Lamb Pines - Update #1

CITY OF LAS VEGAS		DATE:
INTER-OFFICE MEMORANDUM		September 23, 2015
TO: Land Development Services Department of Building & Safety		FROM: Albert Sung, P.E. Flood Control Project Engineer Department of Public Works
SUBJECT:	Drainage Study for:	
	Lamb Pines – Update #1	
Cross Streets:	SWQ of Lamb Boulevard & Bonanza Road	
File Number:	F:\Depot\DSMemos\DS4740C.doc	
Parcel Number:	140-31-501-021	
Zoning Action:	SDR-58124; VAR-58121 to VAR-58123; GPA-57254 & ZON-57255	
FEMA Flood Zone	YES	NO X
Proposed Storm Drain	YES	NO X
COPIES TO:		L. R. Nelson Consulting Engineers Nevada H.A.N.D. Bart Anderson, P.E., DevCo CCRFCD

UPDATE NO. 1 TO THE TECHNICAL DRAINAGE STUDY FOR LAMB PINES

Subject: Update No. 1 to the TDS for Lamb Pines - DS4740UP

PARCEL MAP

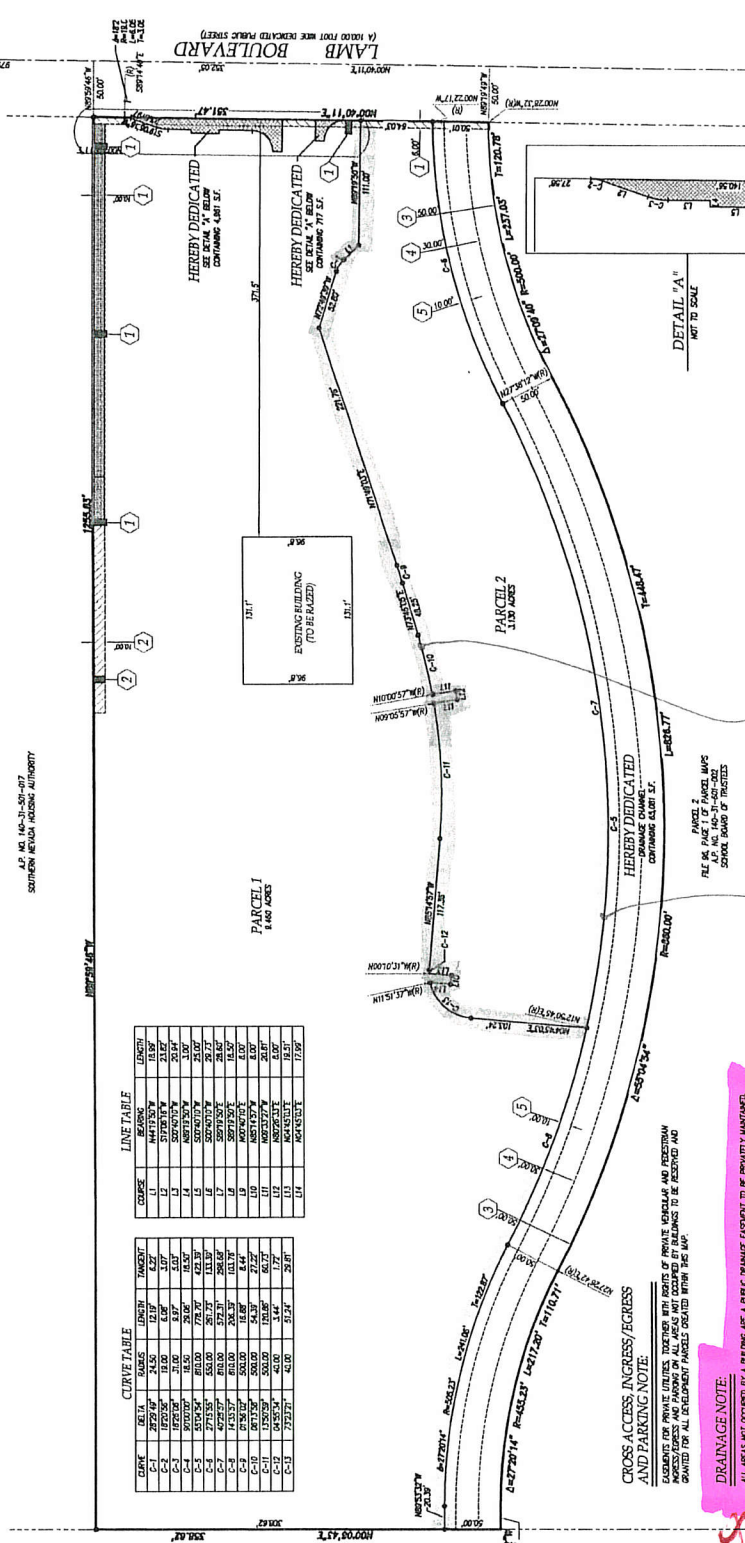
Replace with
Inter-lot
Drainage right
Note.

- This drainage study is acceptable in concept;** however, *City of Las Vegas* will not formally accept the study until the *Clark County Regional Flood Control District* (CCRFCD) has issued a letter of concurrence. The engineer should contact the CCRFCD to confirm that they have begun their review.
- Provide documentation between the engineer/developer and the adjacent property owner to the west to verify due diligence has been exercised by the subject project to mitigate any drainage issues between the two properties.
- Replace the blanket drainage easement in the proposed parcel map with the following note:
ALL SUBDIVIDED PARCELS COMPRISING THIS COMMERCIAL SUBDIVISION SHALL PROVIDE PERPETUAL INTERSITE COMMON DRAINAGE RIGHTS ACROSS ALL EXISTING AND FUTURE PARCEL LIMITS.

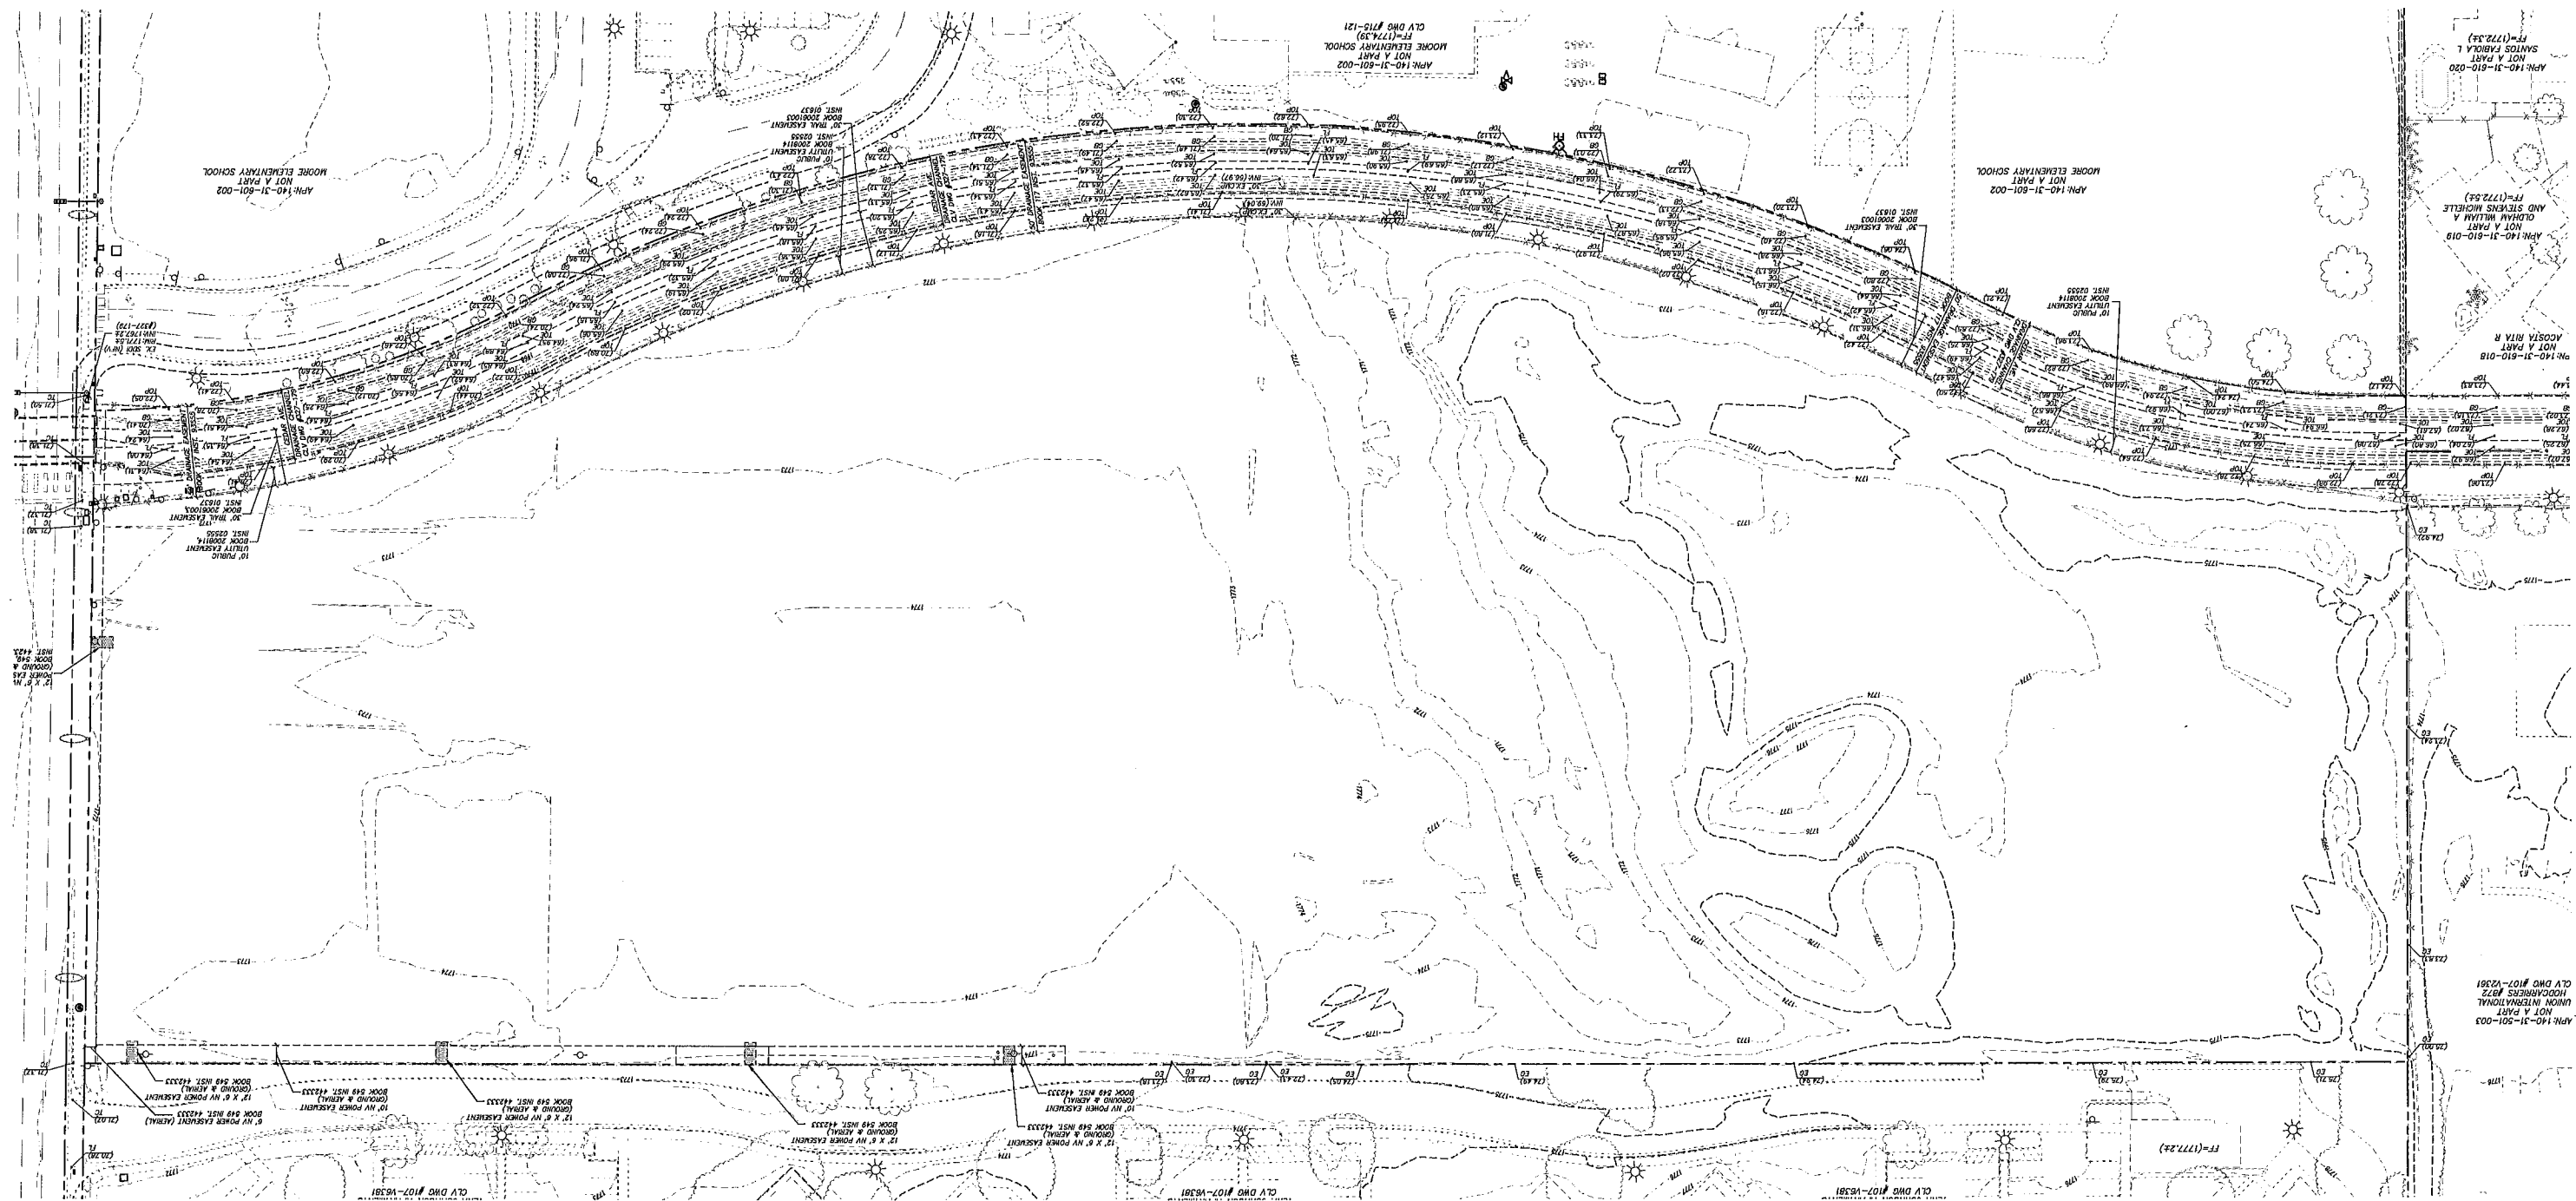
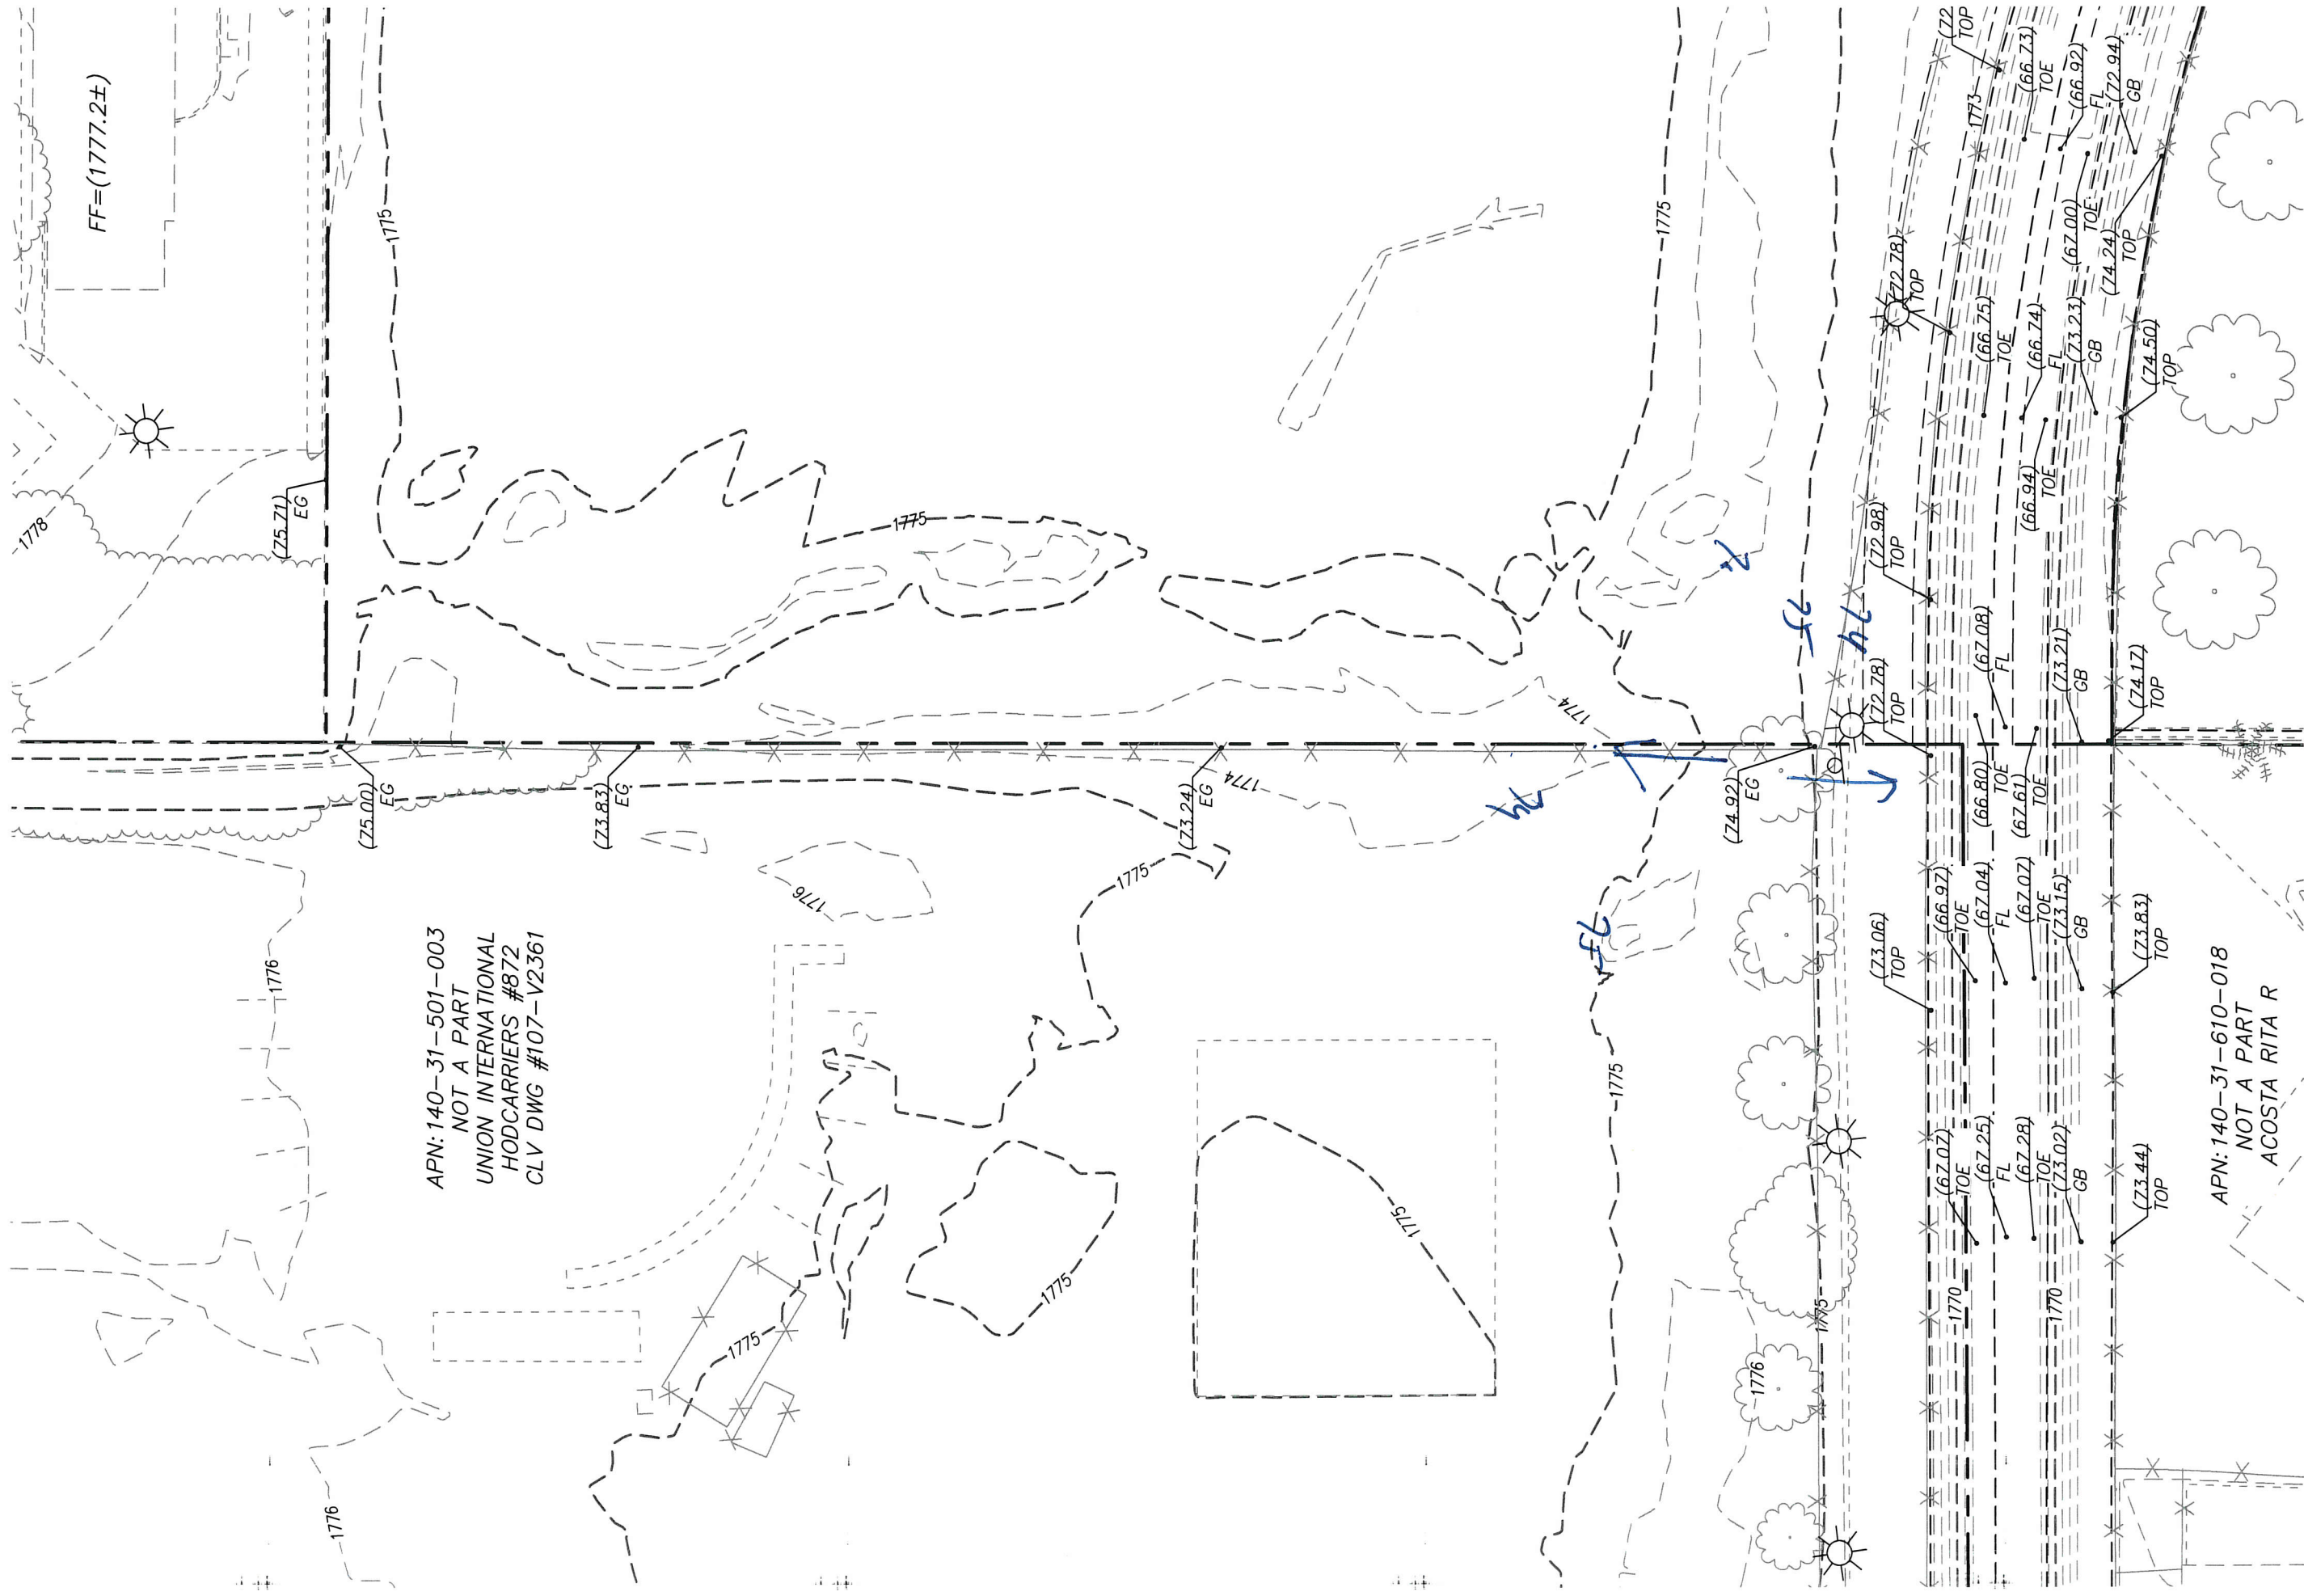
Verify the WSE elevations. They are in the 1900. Revise and e-mail me new sheets.

Notes: Show the Q and HGL on the storm drain profile. Consider grated manhole covers if HGL does not meet 1' below finished grade requirement. Send updated sheet(s).

Attached with this email are the three grading sheets with the revised elevation for the HEC-RAS Sections. Let me know if you need anything else.

There is no need to put a HGL or flow on the profiles because the system is designed to be overtopped during the 100 year event. The HGL for the system is based off of the HGL established as part of the HEC-RAS modeling. All flood waters regardless of storm event will go into the channel. Either by the storm drain or by the emergency overflow provided at each storm grate. Due to the flood levels provide for in the HEC-RAS modeling and the flat slope of the site it is impossible to design a storm drain system that meets HGL requirements. The City of Las Vegas approved this scenario and it is addressed in the report narratives.
